Hi-Fi Products
Service Bulletin

Model: CDP-C235
CDP-C335

No. 390

Subject: Motor Drive Circuit Modification

Subject: Part Number Missing - Reference No. -, Main Chassis

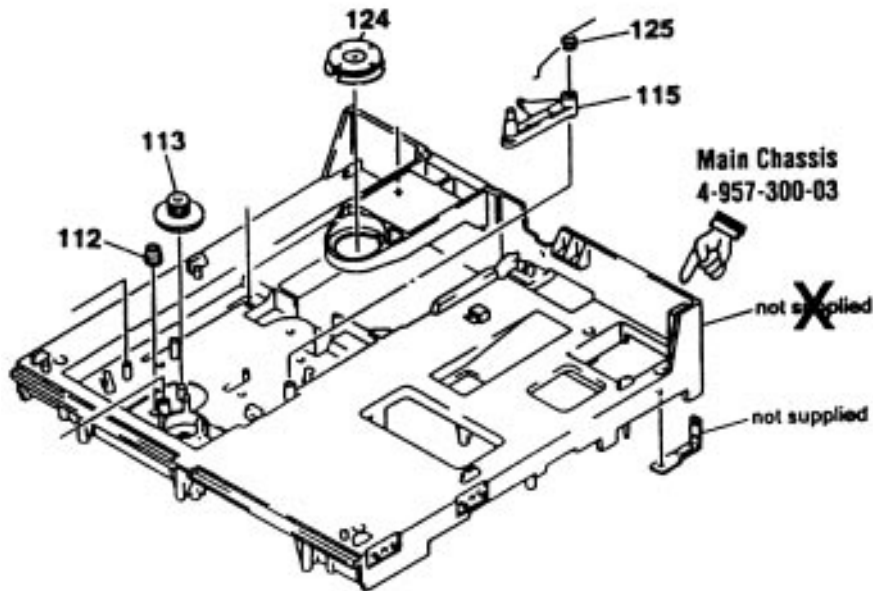
The part number for Ref # -, Main Chassis, which is shown on page 23 of the Service Manual, is not listed in the parts list.

Please add the following part number to the Service Manual.

REF	DESCRIPTION	PART NUMBER
-	MAIN CHASSIS	4-957-300-03

CORRECTION

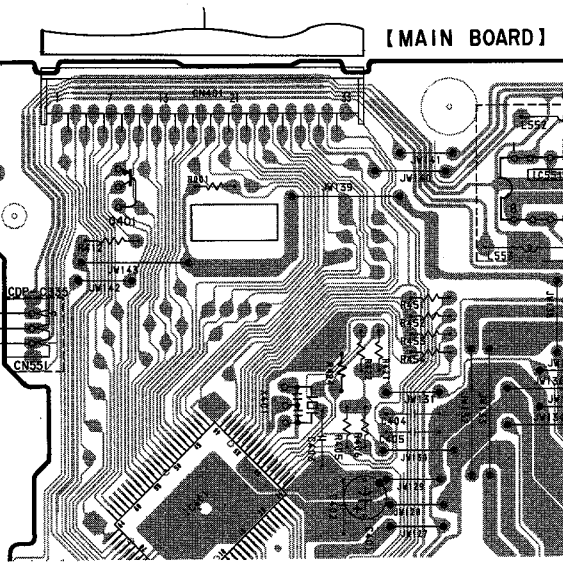
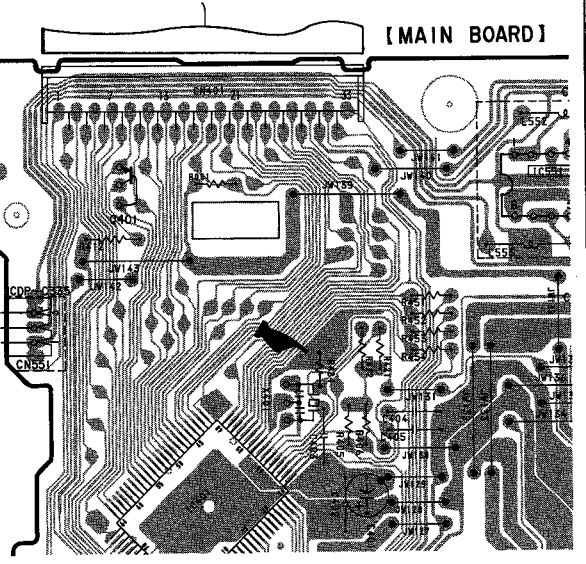
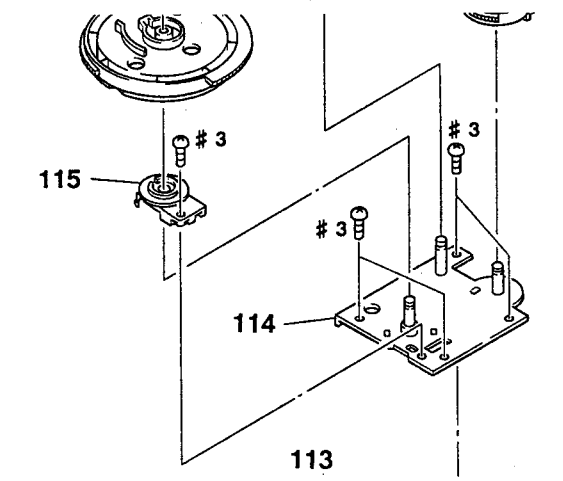
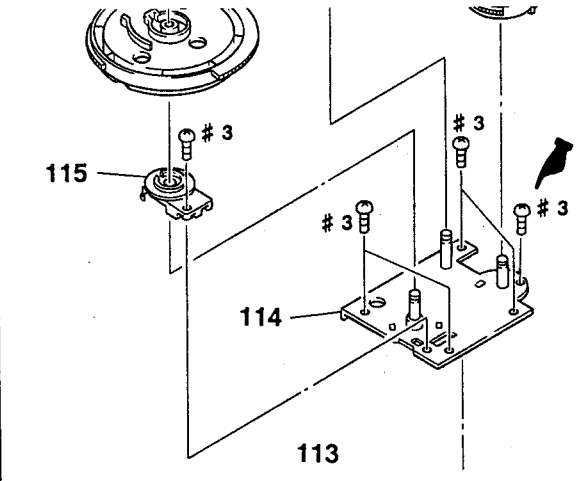
Page	Incorrect	Correct
13	 <p>[MAIN BOARD]</p>	 <p>[MAIN BOARD]</p>
23	 <p>115 #3 #3 #3 #3 114 113</p>	 <p>115 #3 #3 #3 #3 114 113</p>
	121 4-958-593-01 SPRING (BU), COMPRESSION	121 <u>4-948-503-01</u> SPRING (BU), COMPRESSION

Subject: Substitution for KSS-390A

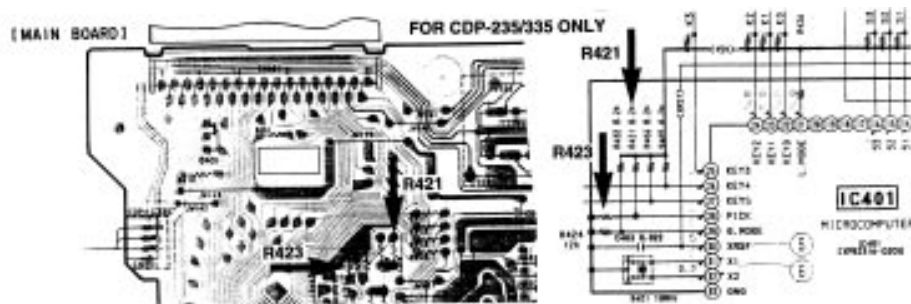
The Optical Block KSS-390A is no longer available and KSS-240A is supplied as the substitution. As the two parts have some electrical and mechanical differences, please perform the following changes according to the model being serviced.

1. Check the value of R421. If it is 8.2K Ω or less, leave it in circuit. Otherwise, remove it and replace it with a jumper wire.
2. Confirm the existence of R423. If it is mounted, remove it. This is needed to keep pin 28 of IC401 High when operating CD function.
3. Replace the flat wire which connects the BD Board and Optical Block with the new type listed below.

Just replace the flat cable with the new type. No circuit modifications needed.

Description	Part Number	Note
Flat Cable	1-575-001-11	This cable must be used with KSS-240A
